THE SIXTH BAPTIST CHURCH RENOVATION AND ADDITION
925 FELICITY STREET
NEW ORLEANS LA 70130

SHEET TITLE:
~~BUILDING SECTION~~
FRAMING PLANS

DRAWING NUMBER:
S103

6 FLOOR FRAMING PLAN
SCALE: 3/16" = 1'-0"

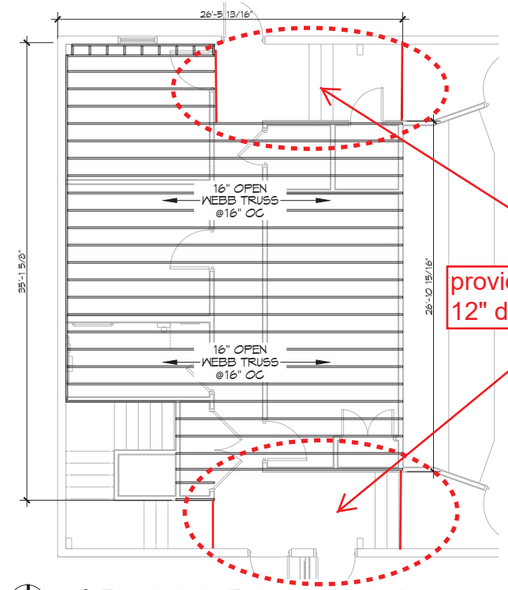
provide framing - 12" deep joists

7 CEILING JOIST FRAMING PLAN
SCALE: 3/16" = 1'-0"

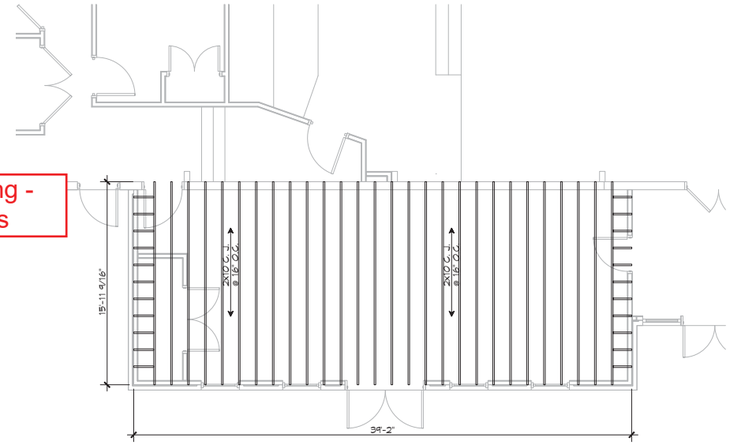
Remove insulation notes

8 FRAMING SECTION
SCALE: 3/16" = 1'-0"

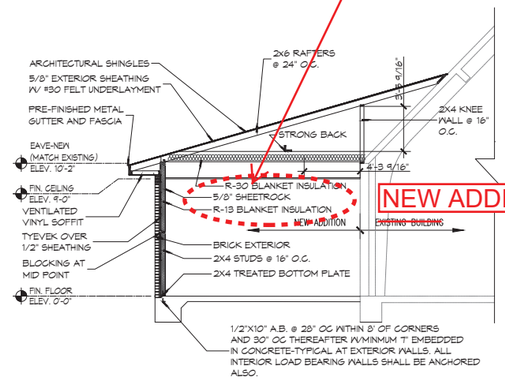
Provide **Roof Framing Plan** for rear portion (coordinate with mech equipment

Provide **Floor Framing Plan** for new soffit framing and new beam at front vestibule below the balcony

update floor plan background

9 FLOOR FRAMING PLAN
SCALE: 3/16" = 1'-0"

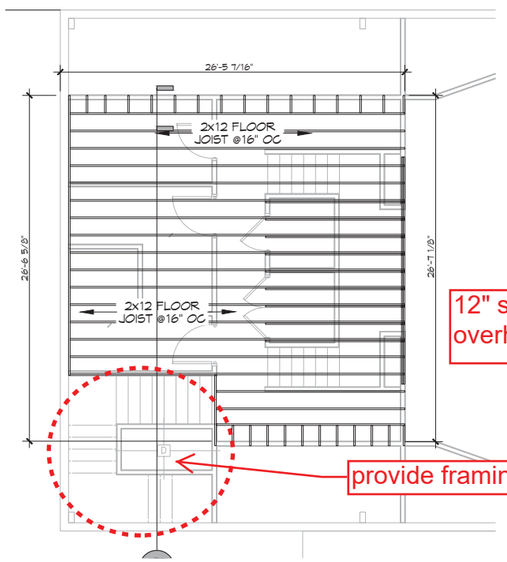
12" side overhang

provide framing

intersection of gable roof must meet point at shed roof, terminates on top of main roof

10 ROOF FRAMING PLAN
SCALE: 3/16" = 1'-0"

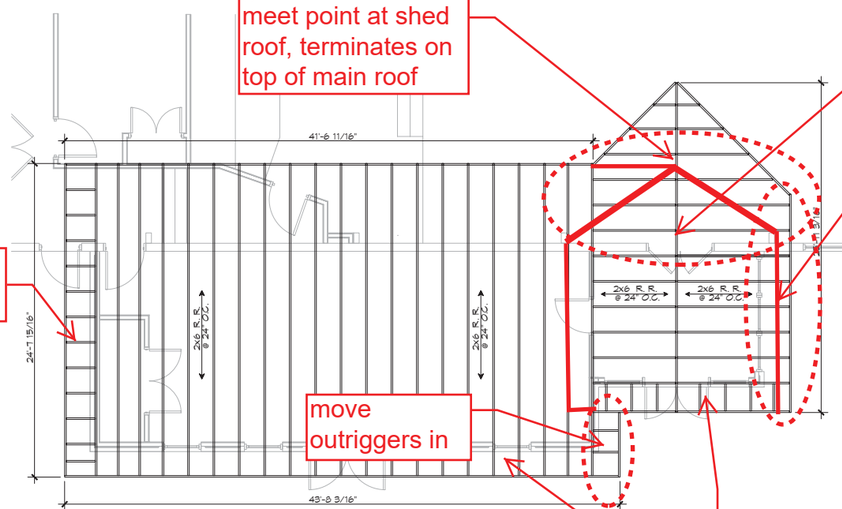
move outriggers in

24" front overhang

vaulted ceiling with exposed ridge beam (boxed framing)-see **wall section A4.4**

12" side overhang

11 PULPIT FRAMING PLAN
SCALE: 3/16" = 1'-0"

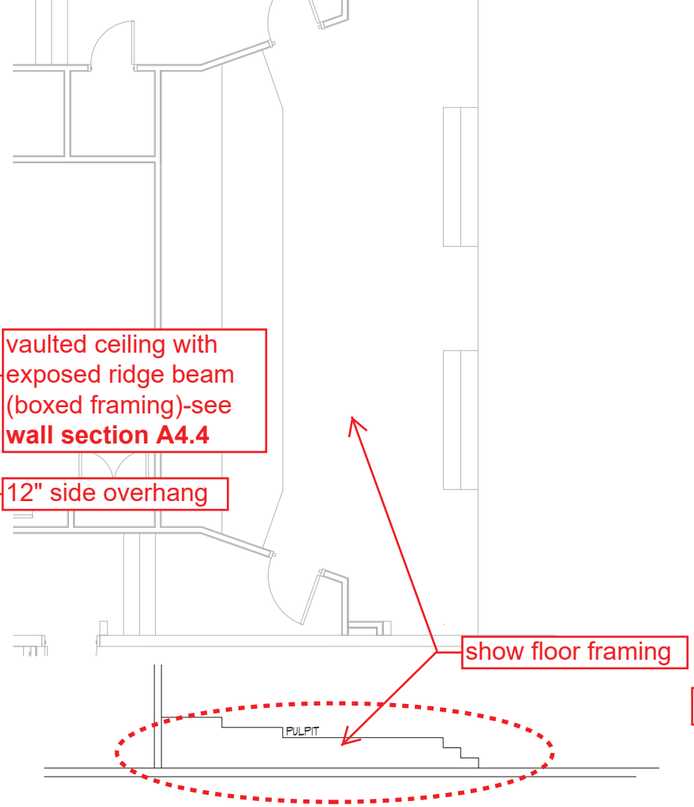
show floor framing
